FLORIDA DEPARTMENT OF TRANSPORTATION – DISTRICT VI

**FDOT District VI Attachment 1
Ramp Volumes
Beacon Countyline DRI**

FDOT District VI Attachment 1
Ramp Volumes
Beacon Countyline DRI

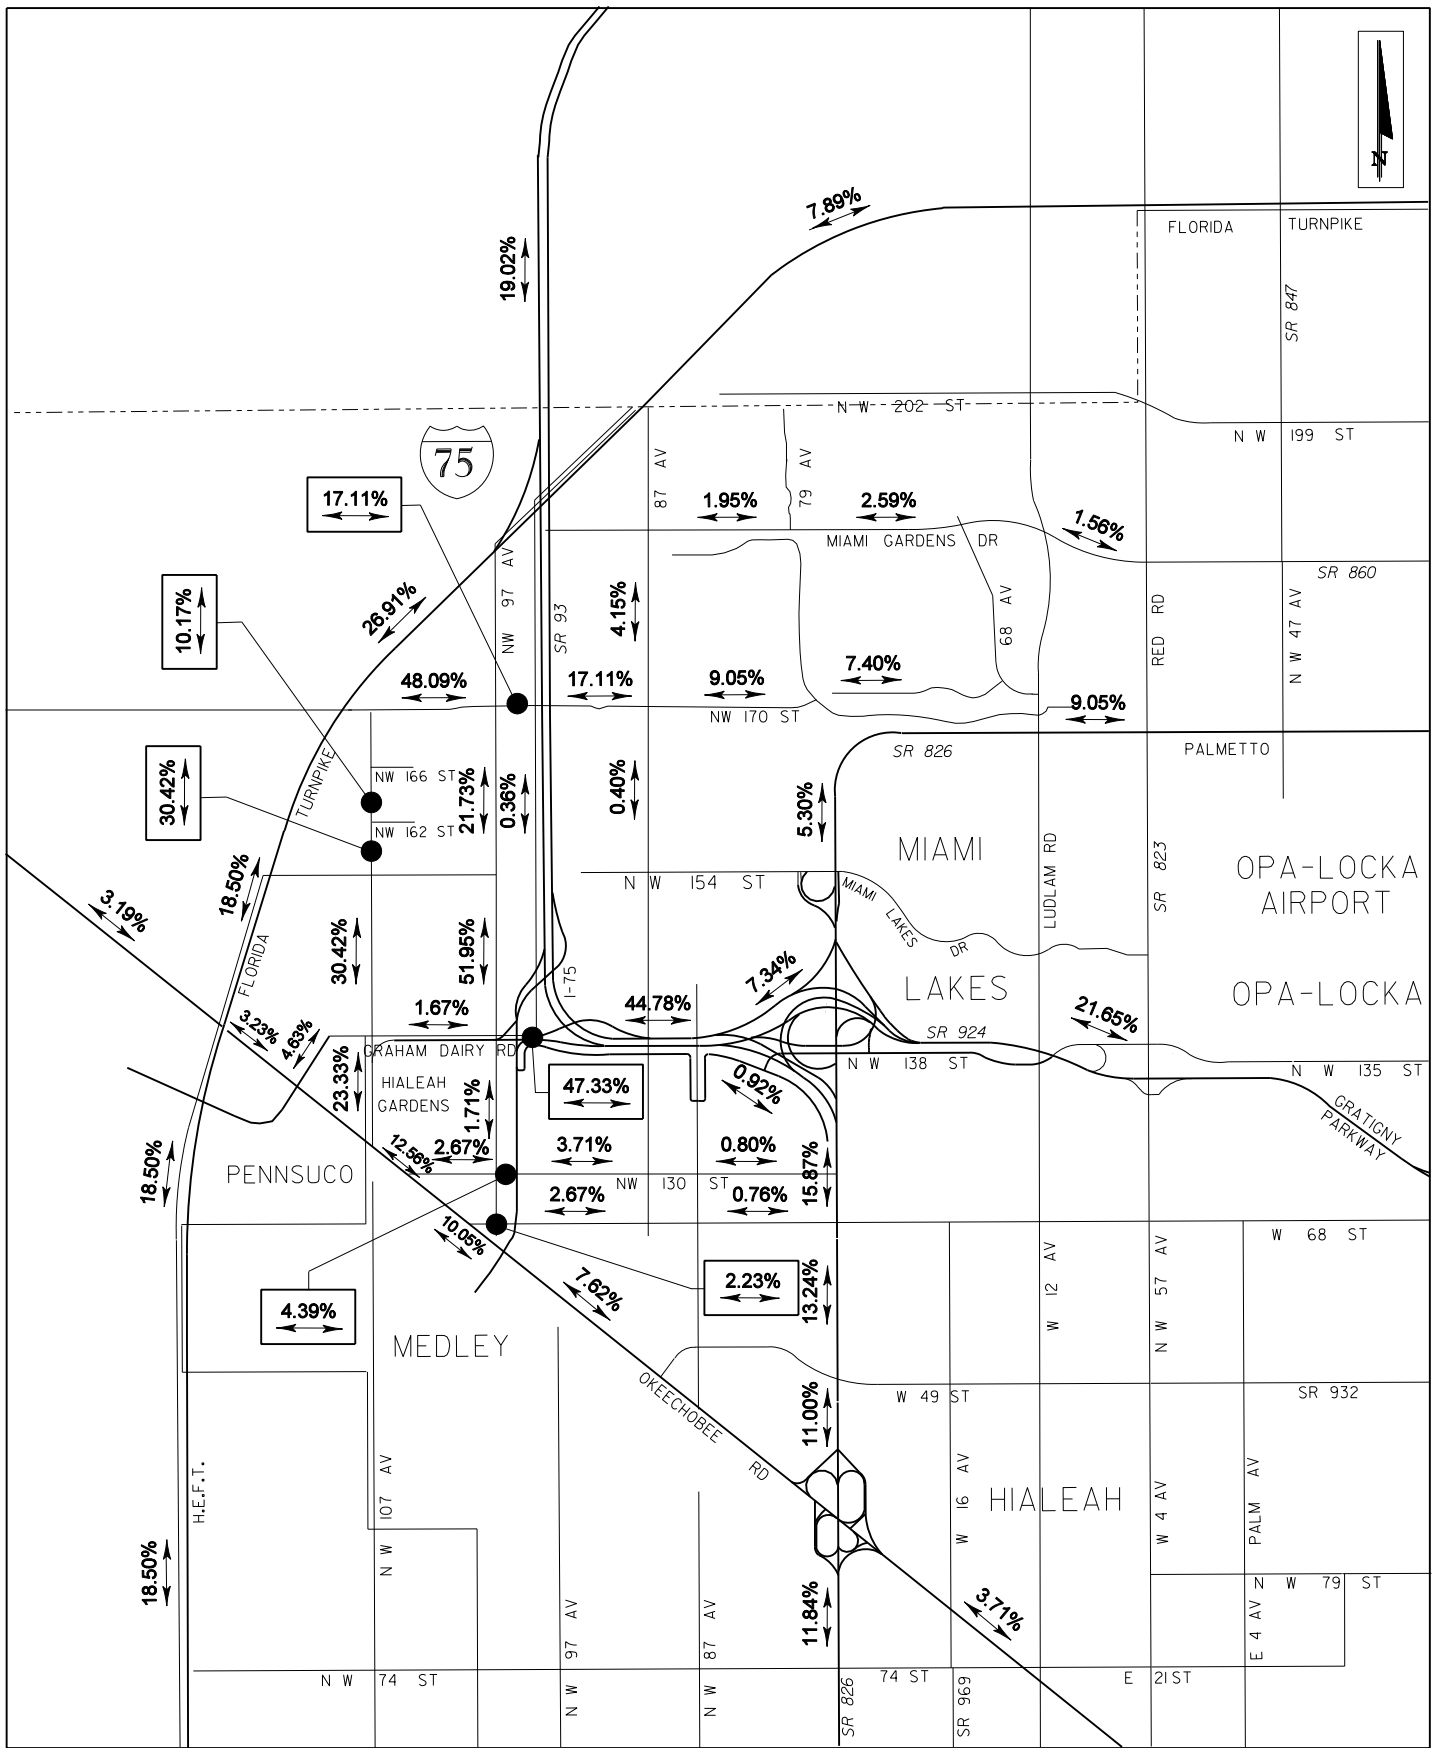
1. **COMMENT:** The ramp operational analysis will have to be reviewed after sufficient documentation on the development of ramp volumes is provided. This would apply to the existing, future background, and future with project analyses.

KAI response: KAI was unable to review the ramp operational analysis because ramp volume development information was not provided in the appendices. The applicant should provide a table with existing and projected ramp volume development. The ramp analyses will be re-reviewed after this additional information is submitted.

APPLICANT RESPONSE: FDOT District VI Attachment 1 – Ramp Volumes provides traffic projections for the ramps analyzed.

APPLICANT RESPONSE: FDOT District VI Attachment 1 – Ramp Volumes provides traffic projections for the ramps analyzed.

FDOT District VI Attachment 2
 PROJECT DISTRIBUTION
 Beacon Countyline DRI

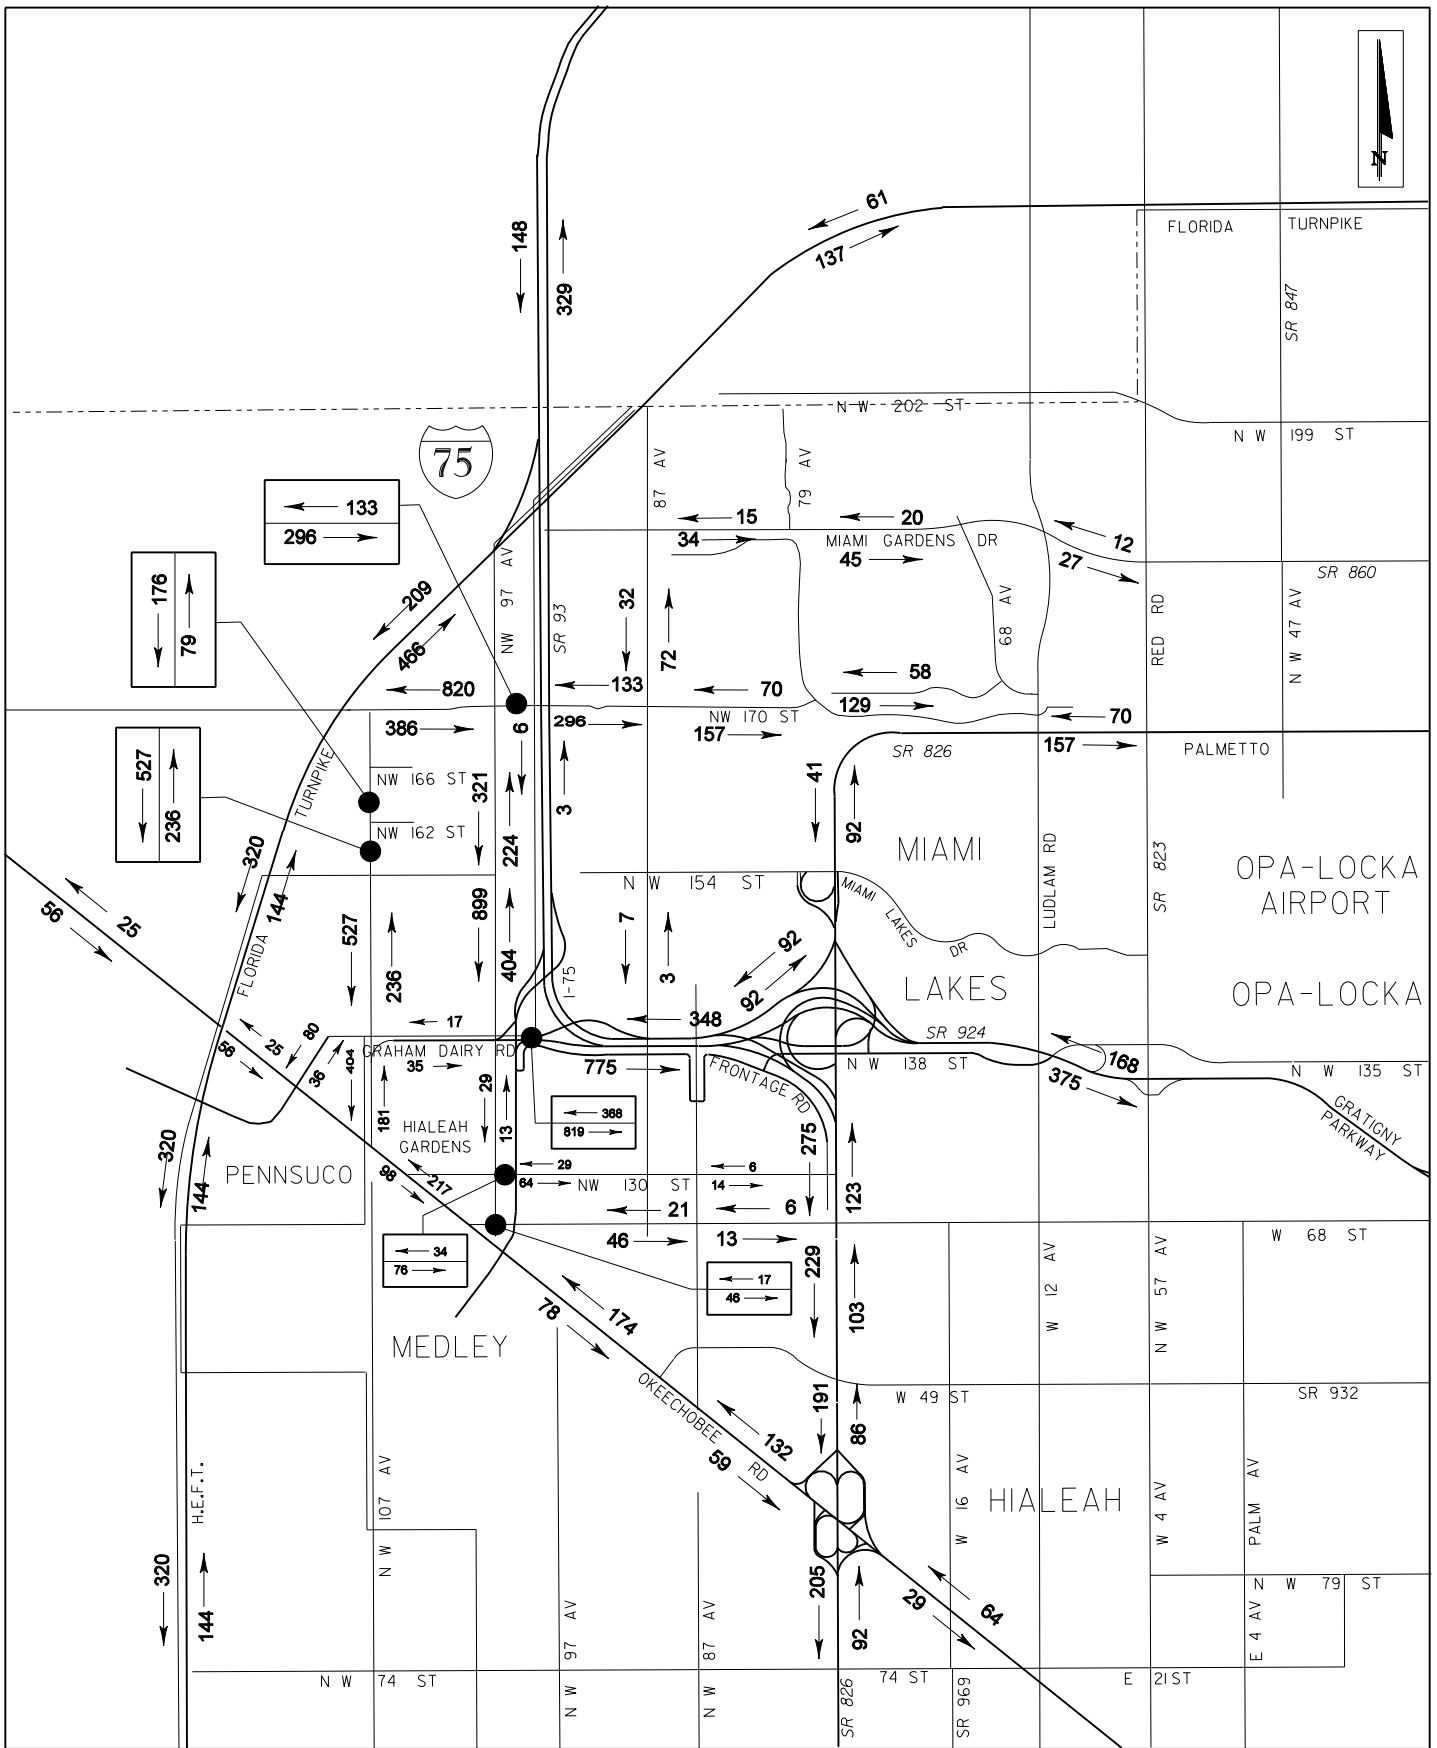
2. **COMMENT:** We require separate maps showing project distribution (percent) and project traffic assignment (number of project trips).

KAI response: Not addressed. A project assignment and a project distribution map (one of each) must be provided. These maps must depict the entire study area, not just the roadways adjacent to the proposed development.

APPLICANT RESPONSE: FDOT District VI Attachment 2 – Project Distribution and FDOT District VI Attachment 3 – Project Assignment provide project traffic assignment and project traffic distribution maps as requested.

APPLICANT RESPONSE: FDOT District VI Attachment 2 – Project Distribution and FDOT District VI Attachment 3 – Project Assignment provide the information requested.
